**REQUEST FOR INFORMATION      DATE: December 08, 2016      NO.: RFI-375**

Project Name: 15051-Webster University Interdisciplinary Science Building      Project No.: 15051

Subject: South courtyard wall

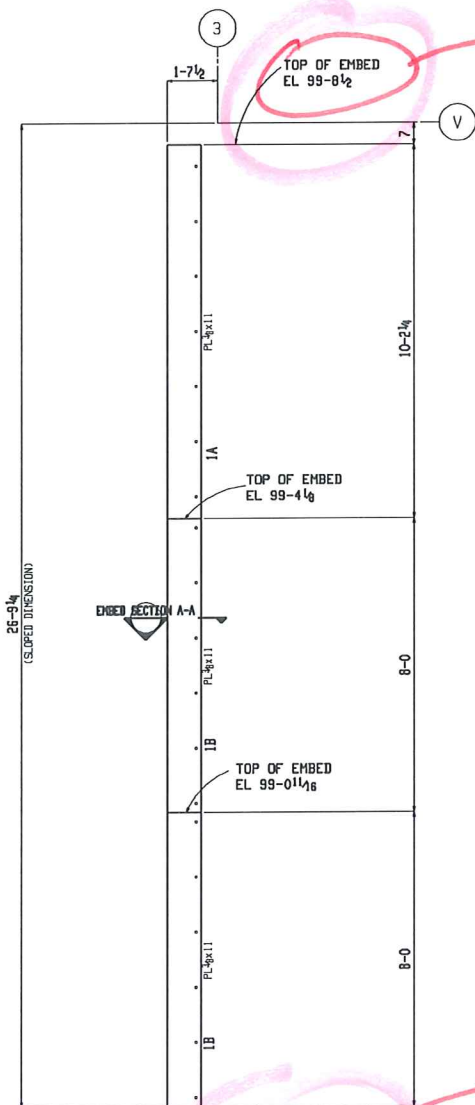
See attached sketch for proposed solution. The difference between the high point (7" south of V) and the low point (at the stair top riser line) of the sloped wall appears to be 1'-1 ¼", not the 1'-0" shown on 2/A0507.B (555.37' minus 554.37')

The proposed solution is acceptable - please make this change - thanks for suggesting. Please note that RFI 259 response showed a very similar solution to this issue.

ELEVATION AT 'A-A'  
(LOOKING EAST)

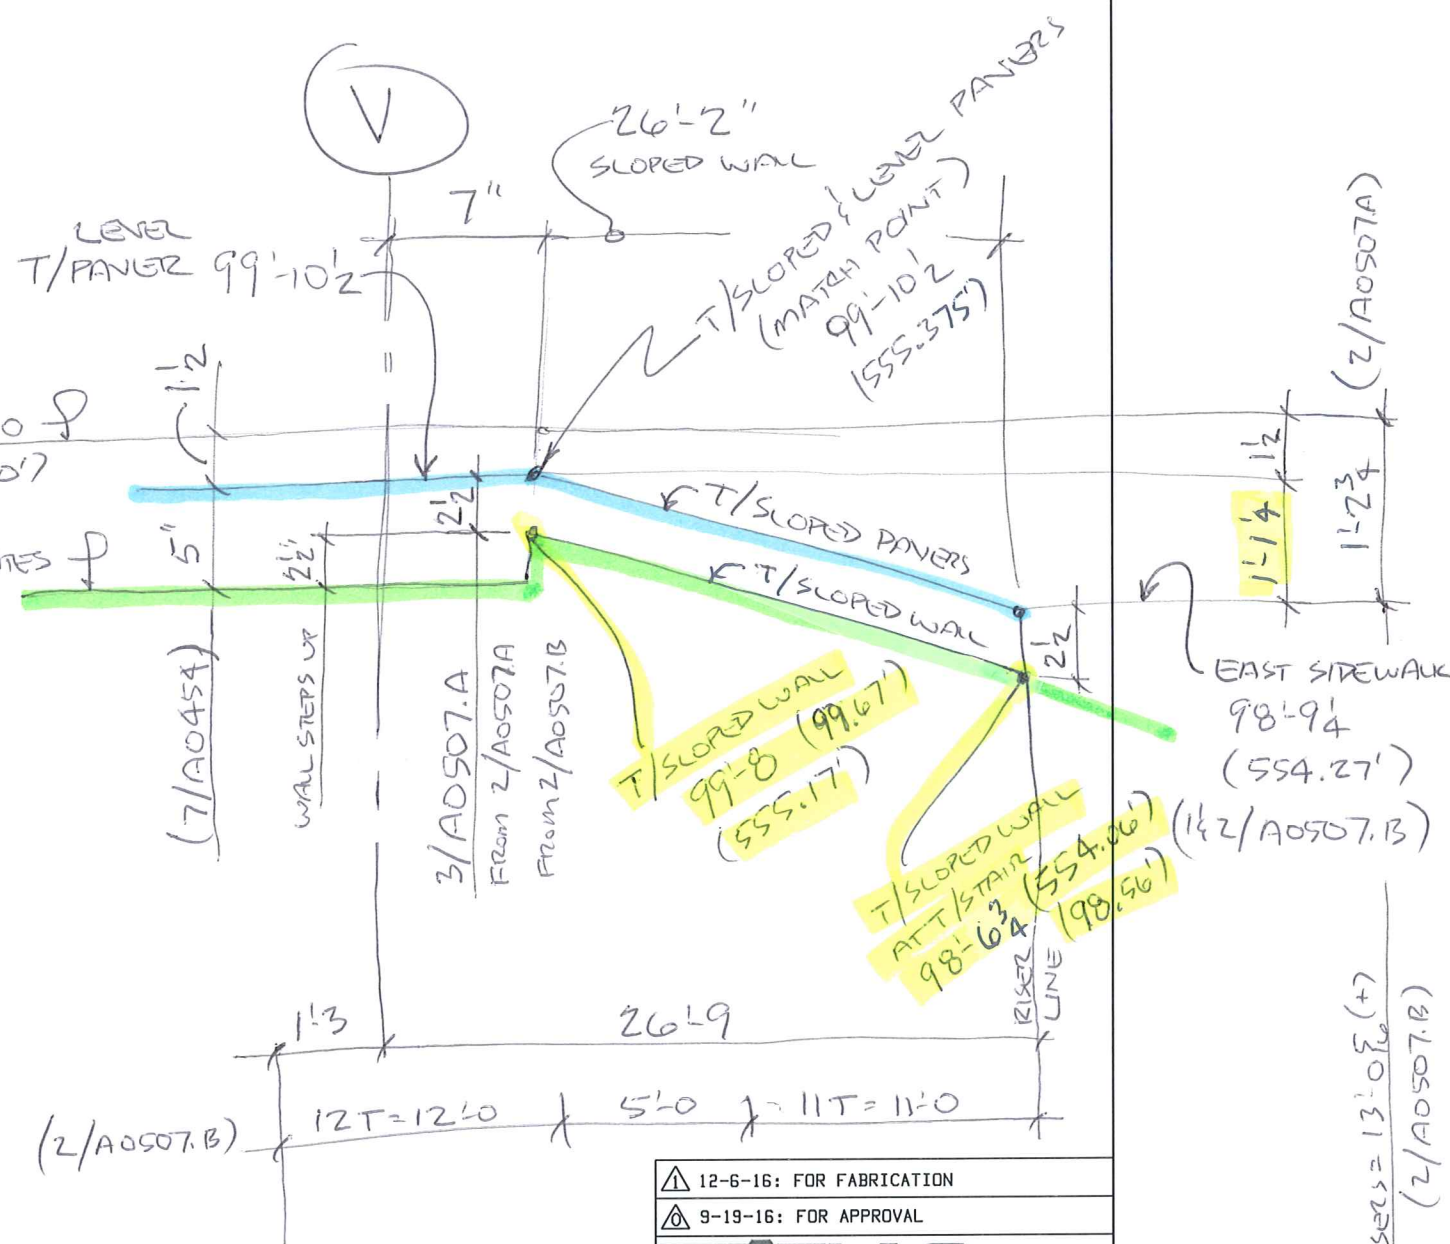
Detail 2/A507.B shows a top of wall elevation at 555.37' (99.87') where the building and retaining wall meet. Detail 7/A0454 shows the top of paver 1 ½" below 100' at 555.375' (99.875'). This will result in a step up in paver elevation at this transition.

This sketch is based on the top of the sloped pavers (above the sloped wall) matching the top of the level pavers north of line V, and the top of the 'east sidewalk' at the top of the stair.
